# **8600 WILSHIRE MIXED-USE PROJECT FINAL ENVIRONMENTAL IMPACT REPORT**

**Prepared for**  
**CITY OF BEVERLY HILLS**

## 8.0 COMMENTS AND RESPONSES

**PLANNING COMMISSION COMMENTS AT THE APRIL 27, 2006 PUBLIC HEARING**

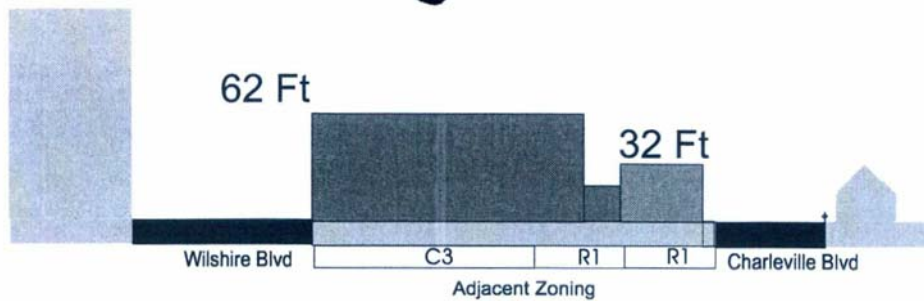
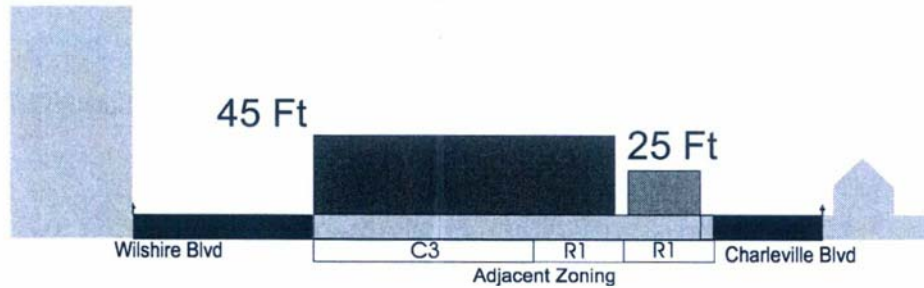
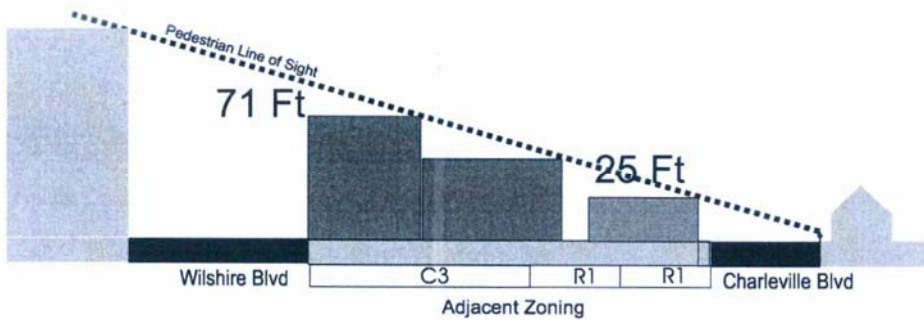
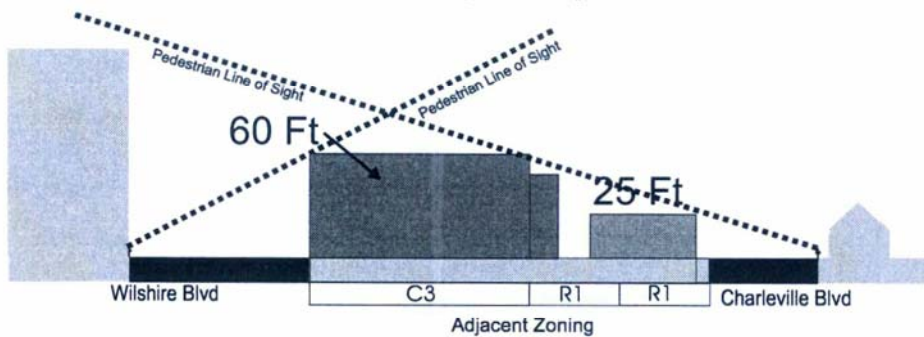
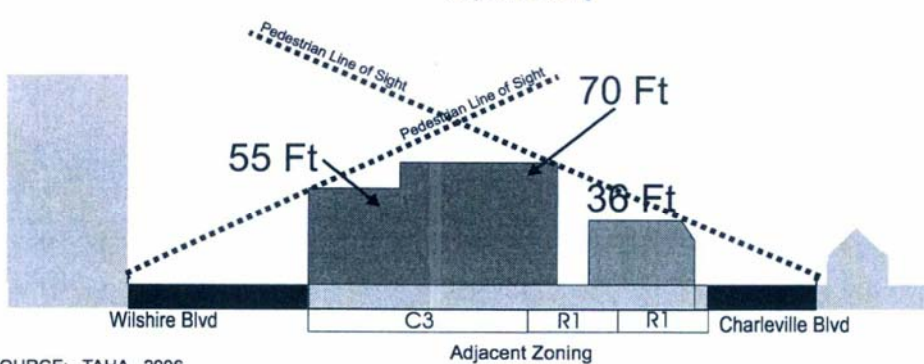
Modify Alternative #3 – 55' height on Wilshire and 36' sloped roof on Charleville.

As shown in **Figure 8-19**, below, if the height of the proposed mixed-use building is 55 feet along Wilshire Boulevard, rather than 60 feet, and the height of the proposed townhouses is 36 feet with a pitched roof, rather than 25 feet with a flat roof, the height of the southern portion of the mixed-use building could extend up to 70 feet without being in the line-of-sight of pedestrians from the south side of Charleville Boulevard. However, the ceiling height of the apartment units along Wilshire Boulevard would be substantially reduced and would not be consistent with the applicant's objective for the proposed residential units. The southern portion of the mixed-use building, which could accommodate for a height of up to 70 feet without being in the line-of-sight of pedestrians from the south side of Charleville Boulevard, would not be tall enough to accommodate for an additional apartment unit and would make the floor-to-ceiling height of the proposed apartment units be greater than the proposed Project.

Although this alternative would have a taller mixed-use building than the proposed Project, shade and shadow impacts would be similar to the proposed Project since portions of the homes, backyards, and garage structures to the west of the Project site would be covered by shadows between 8:00 a.m. and 11:00 a.m. throughout the various seasons of the year. All other impacts associated with this modified alternative would also be similar to the Alternative 3 that was discussed in the Draft EIR.

## SCENARIO 1: REDUCED RESIDENTIAL WITH EXPANDED RETAIL

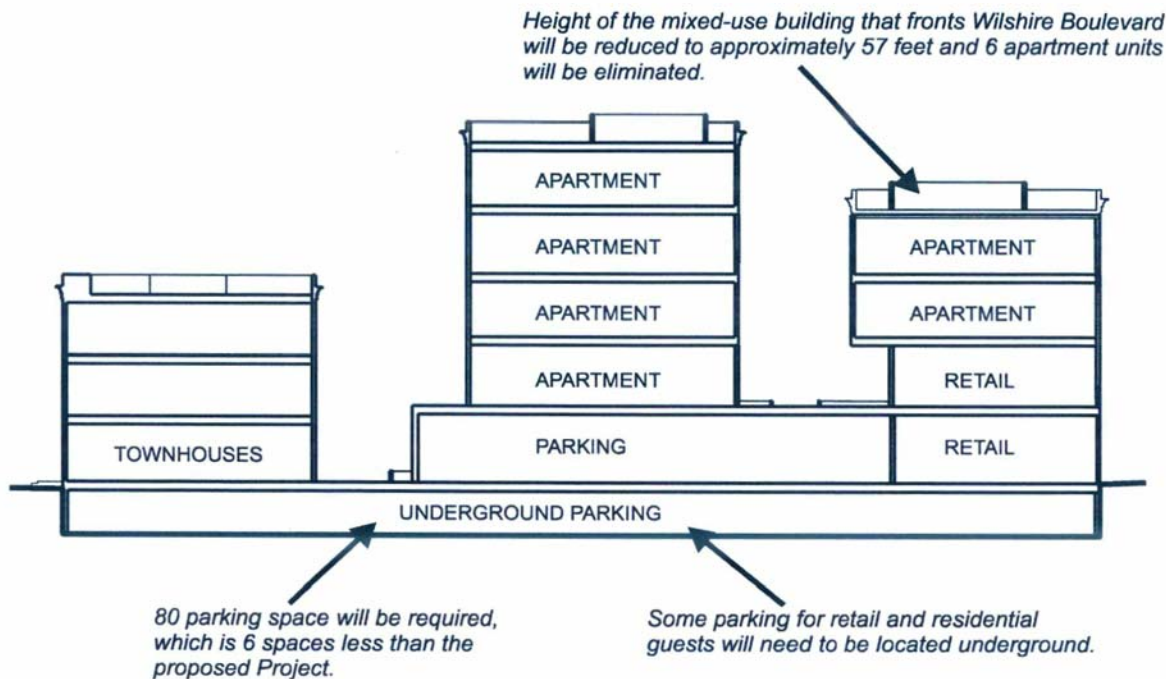
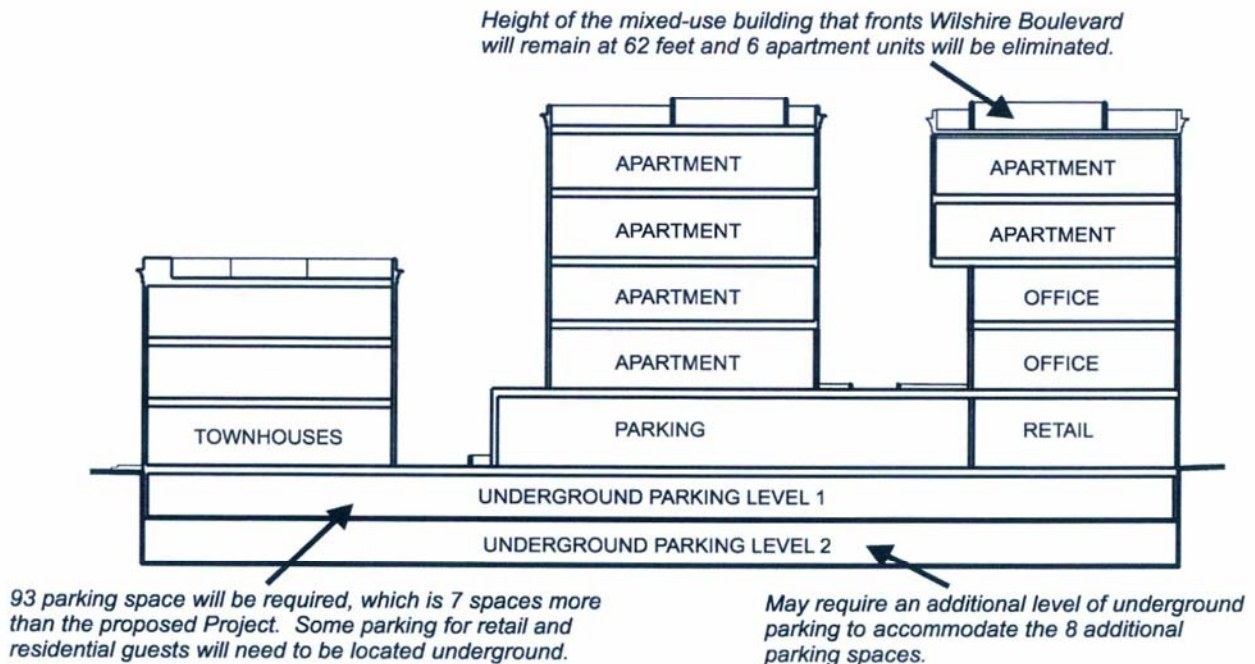
Add alternative that expands retail (Alternative # 3A).

The Planning Commission expressed a desire to increase the commercial component of the proposed mixed-use Project. The current proposal devotes approximately 4,800 square feet to retail use, which is less than 10 percent of the overall Project development. Two scenarios can occur under the Expanded Commercial Alternative. The two options to expand the commercial component of the proposed Project and their implications are discussed below and are shown in **Figure 8-20**, below.

**Scenario 1 - Reduced Residential with Expanded Retail.** This option would double the amount of retail space to approximately 9,550 square feet by providing retail on the ground and second level in the portion of the mixed-use building that fronts Wilshire Boulevard. The third and fourth floors would be split-level apartment units.

**Scenario 2 – Reduced Residential with Two Levels of Office.** This option would maintain the ground floor retail space and add two levels of office space above the ground floor. Approximately 14,320 square feet of commercial space would be created. The fourth and fifth floors of the Wilshire Boulevard frontage of the mixed-use building would be split-level apartment units.
